AMENDMENTS TO THE DRAWINGS

The attached sheet 3/8 of the drawings includes changes to Fig. 3. This sheet, which includes Figs. 3-4, replaces the original sheet that included Figs. 3-4.

REMARKS/ARGUMENTS

Fig. 3

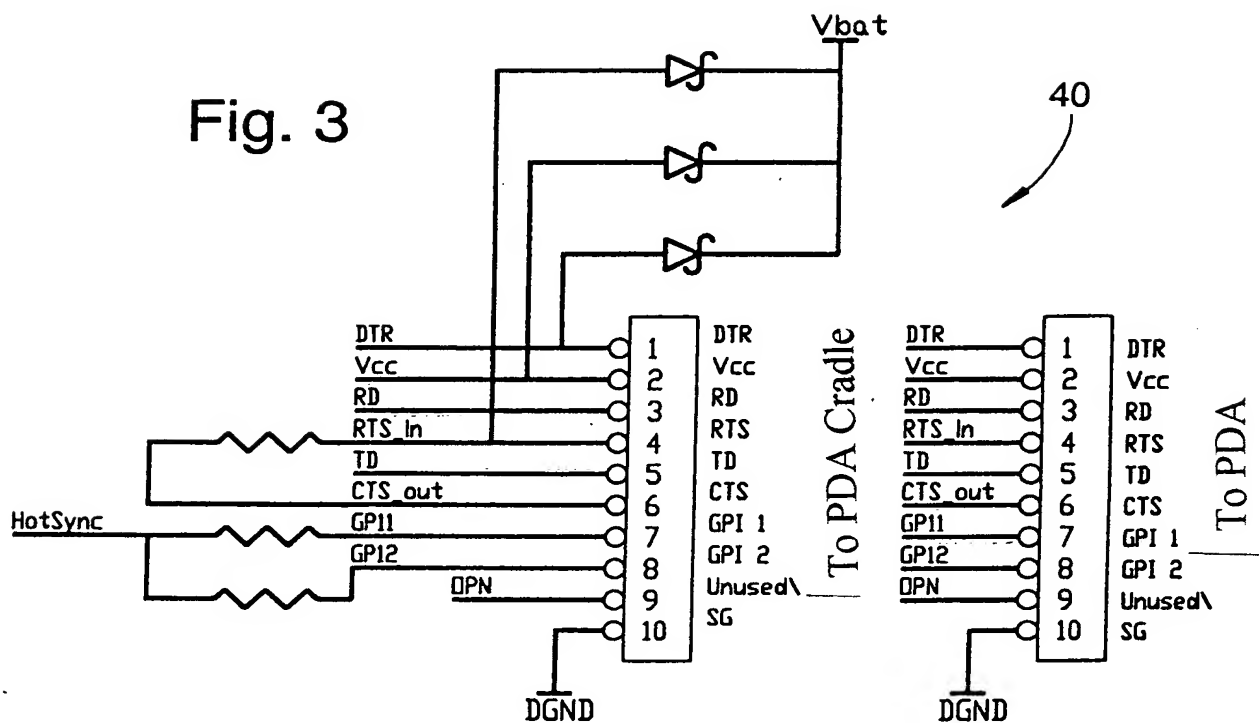
In Fig. 3, the caption “To Plam” was a misspelling of “To Palm” and has now been amended to “To PDA,” to correctly indicate that the illustrated interfaces are applicable to any type of PDA. Palm is a registered trademark of Palm, Inc. of Santa Clara, California, and Applicant does not wish to use that designation as one example. No new matter has been added.

Additionally, in Fig. 3, the caption “To Cradle” has been clarified to read “To PDA Cradle.” This clarifies the ability of the MSR unit to interface with both the PDA and the PDA’s cradle by being positioned between the two. No new matter has been added.
